MEMORANDUM

SUBJECT: Office of Planning (OP) Report on Application ZC 06-10G -- Request for a Modification

of Consequence to approved PUD 06-10, Arts Place at Fort Totten

Figure 1.PUD Site Plan, with Completed Building A to Left and Current Application's 2nd Stage PUD Labelled "B"

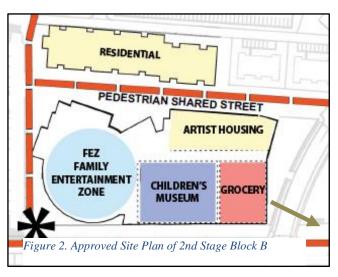
- Add a northern extension to the wing on the west side of the former 4th Street, to contain an additional 23 market-rate residential units. This would be on the right side of the wing labelled "residential" in Figure 2 above (Exhibit 2C2, page 1);
